TRANSMITTAL COVER SHEET

DATE: 25 June 2024
TO: ALL PLAN HOLDERS OF RECORD
FROM: HUNTER SWATEK, AIA, PROJECT MANAGER
PROJECT: RAINBOW CITY RECREATION CENTER
GMC PROJECT NO. ABHM230021
RE: ADDENDUM NO. 4 AND
ACKNOWLEDGEMENT OF RECEIPT OF ADDENDUM NO. 4

ADDENDUM NUMBER 04

**PROJECT: RAINBOW CITY RECREATION CENTER
GM&C PROJECT NO. ABHM230021**

AMPHITHEATRE PLANS

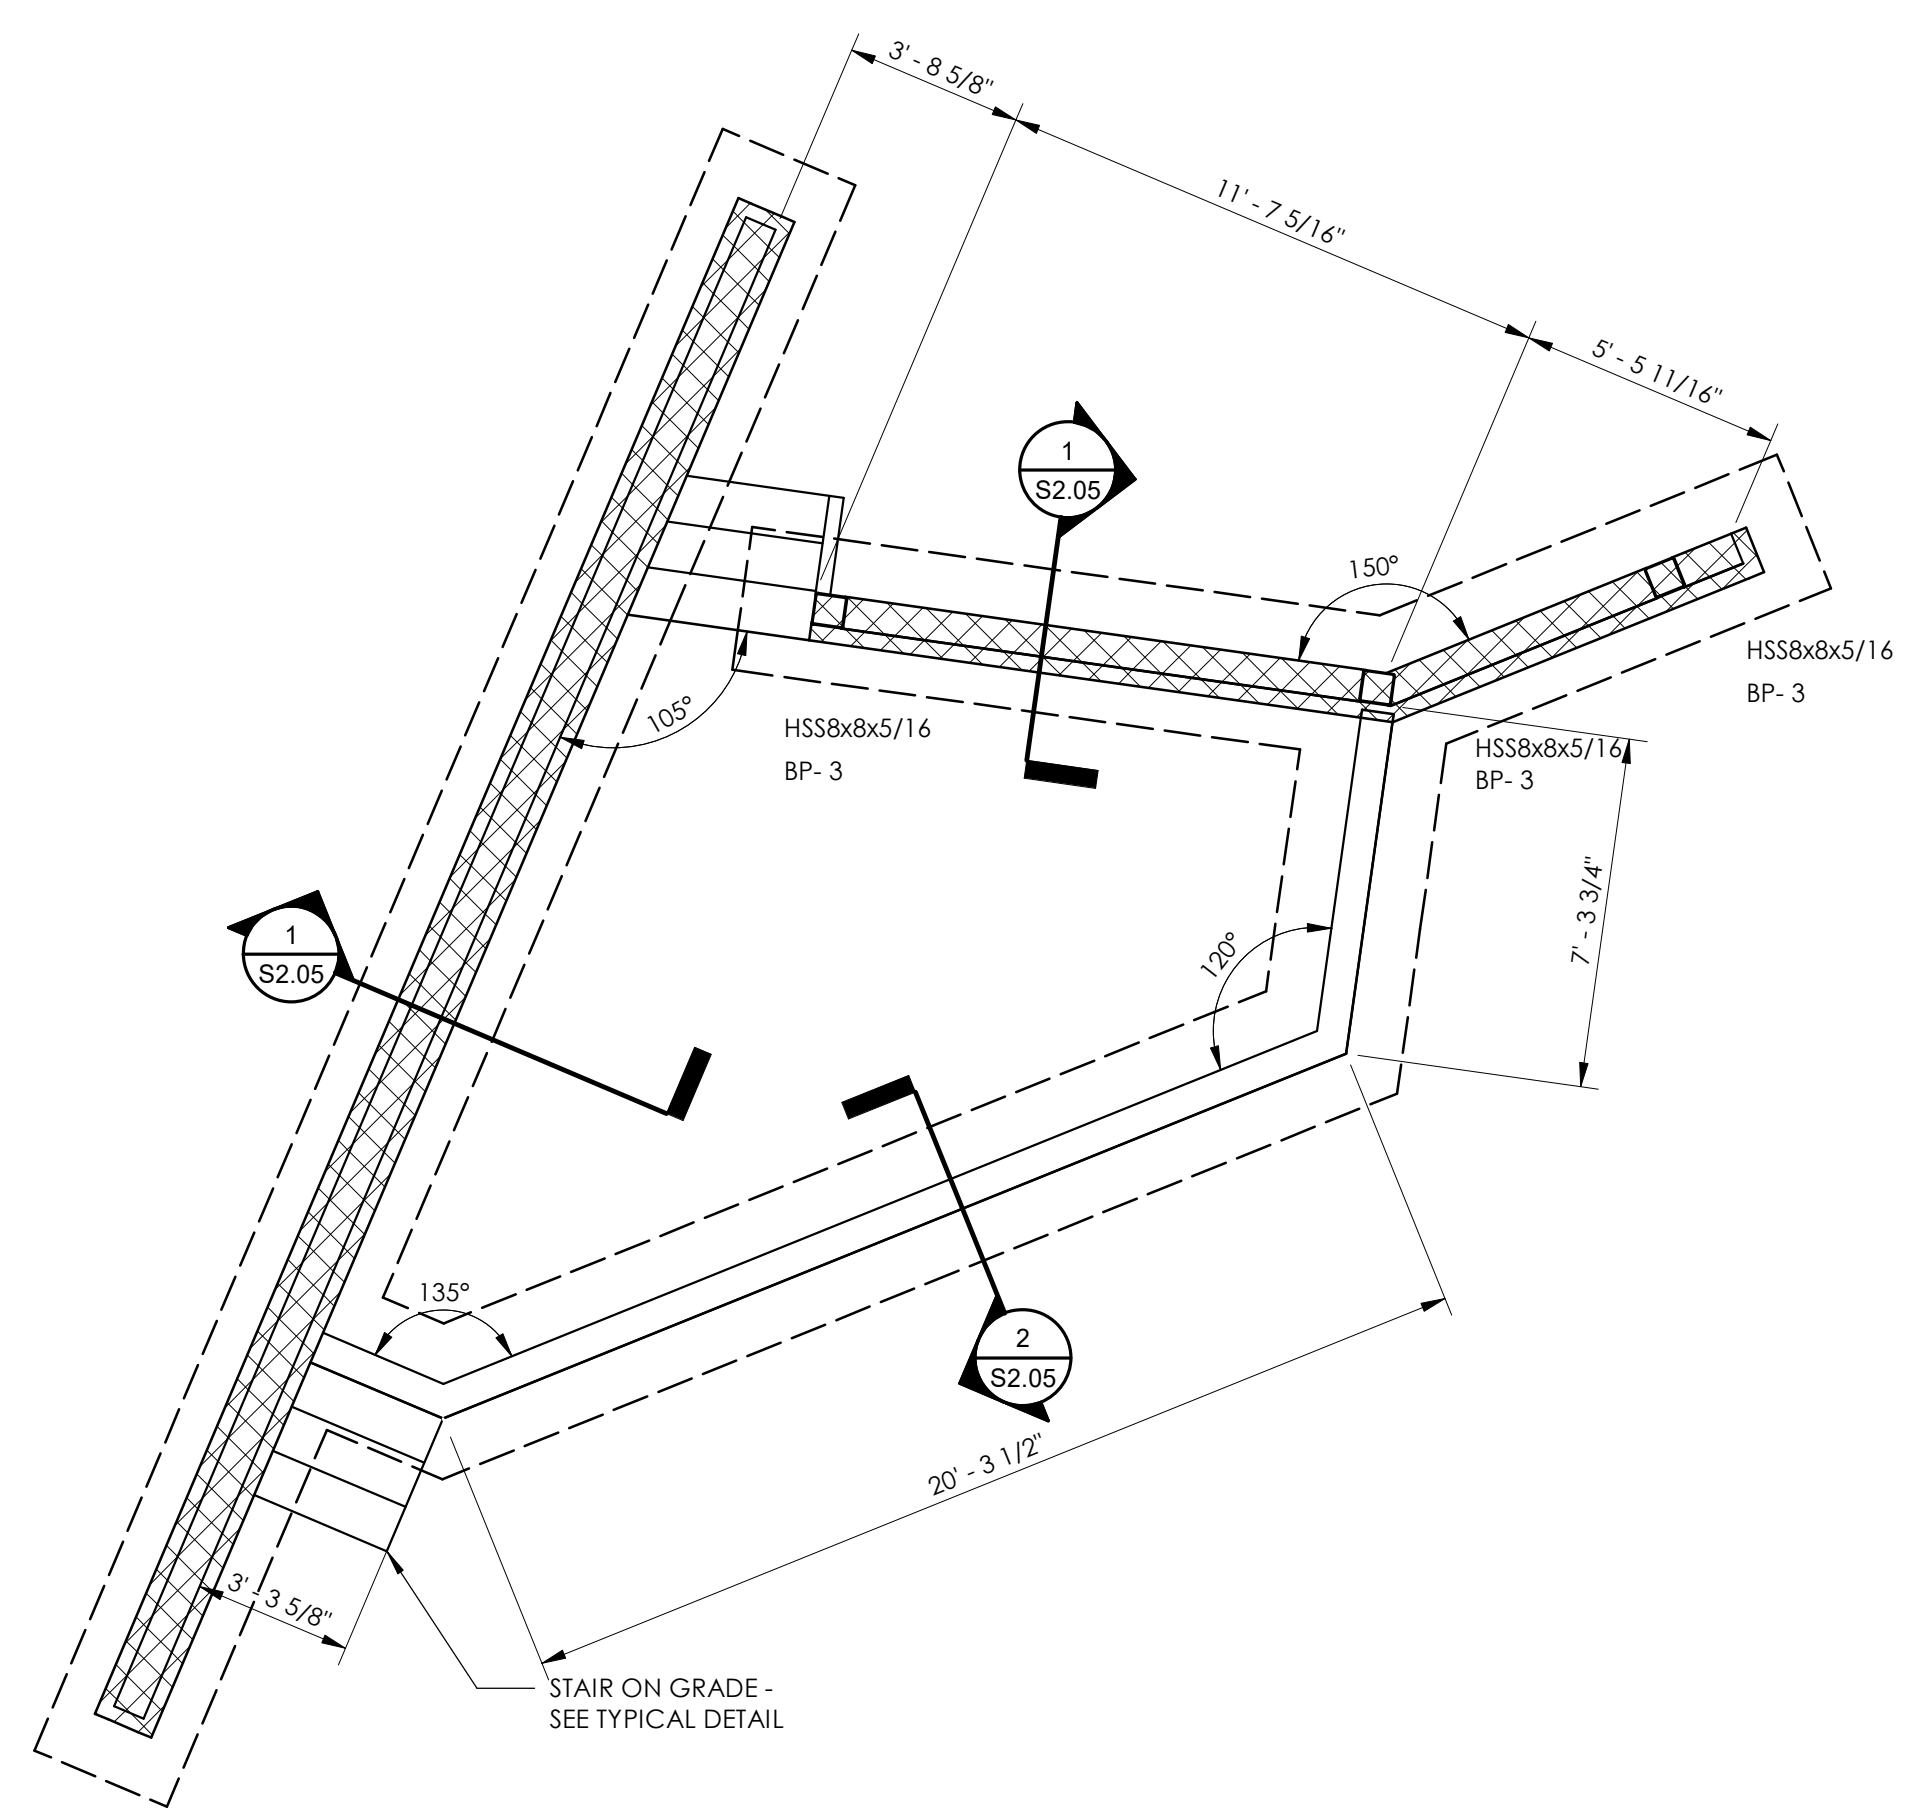
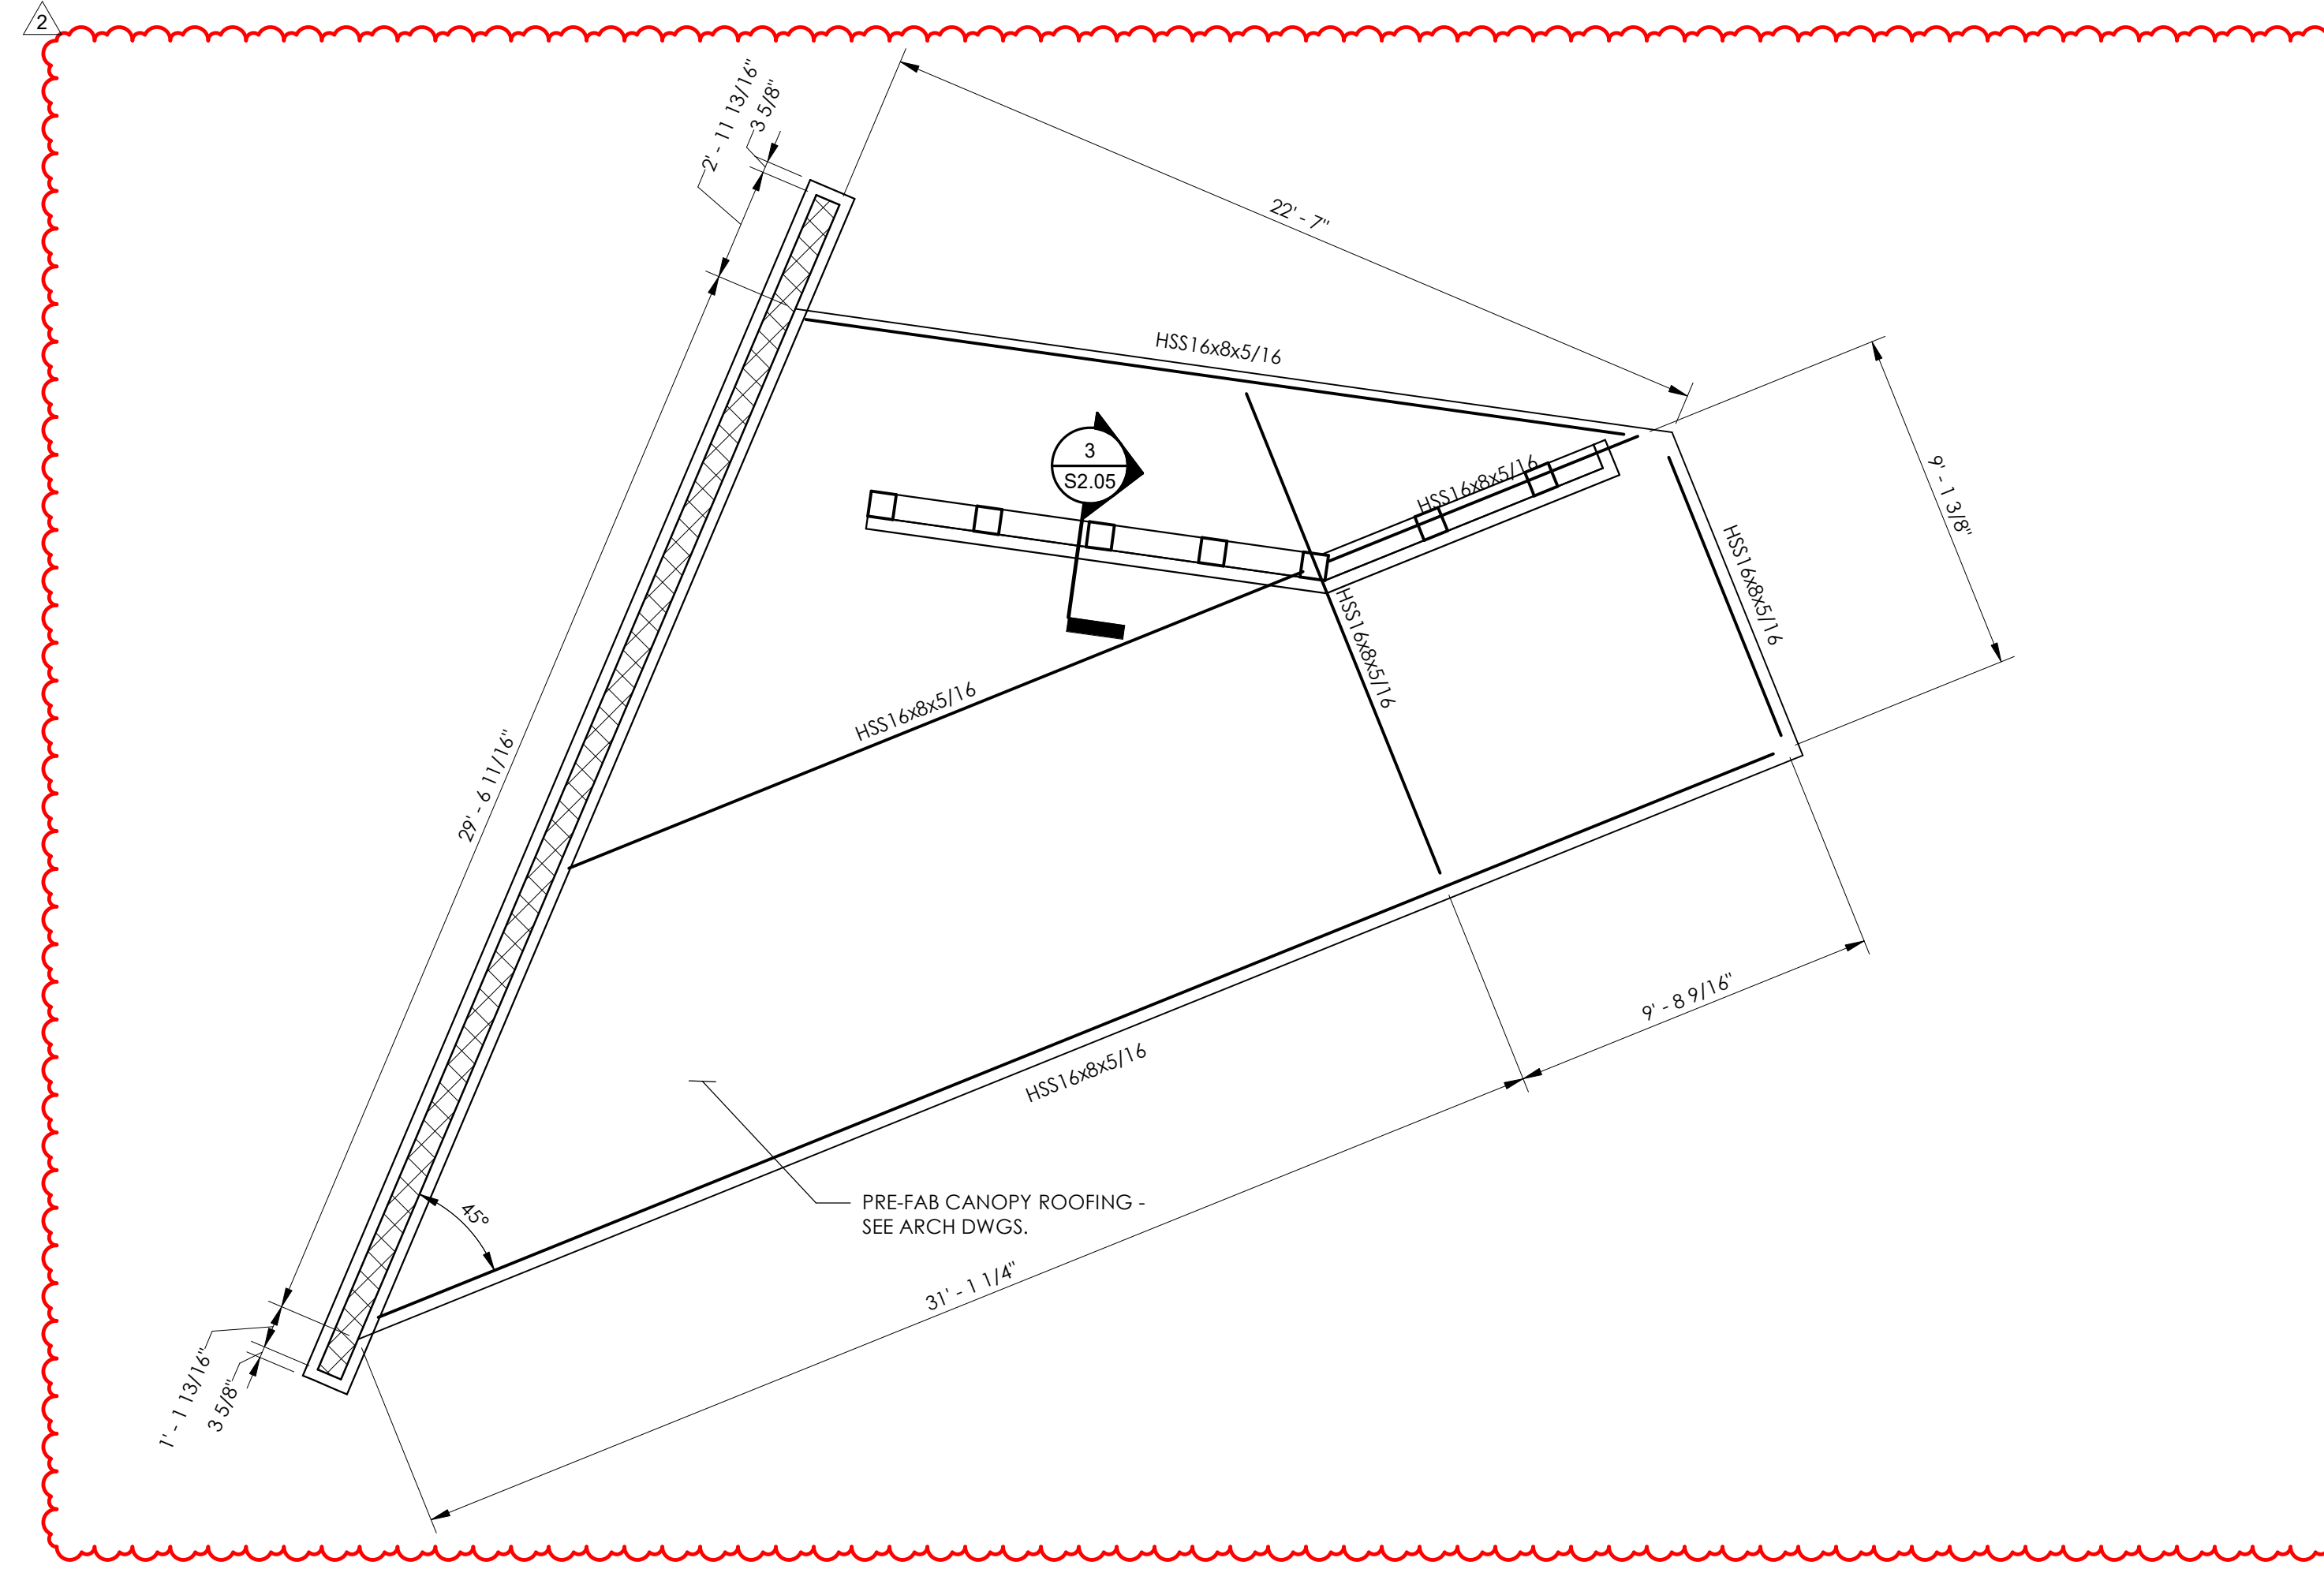
- a. ADDED New Sections
- R. **S2.05** – Amphitheatre Plans
 - a. REVISED Amphitheatre Canopy
- S. **S3.05** – Sections
 - a. CREATED New Section
- T. **E0.02** – Electrical Site Power
 - a. REVISED Transformer Pad Location
- U. **E5.02** – Panelboard Schedules and Diagrams
 - a. REMOVED RPA1 to RPB2 Connection
- V. **E7.01** – General Electrical Legend & Notes
 - a. ADDED FB1 Note
- W. **SP1.01, SP1.02, SP2.01, SP2.02, SP2.03, SP2.04** – Pool Addendum 04
 - a. REVISED Drawings
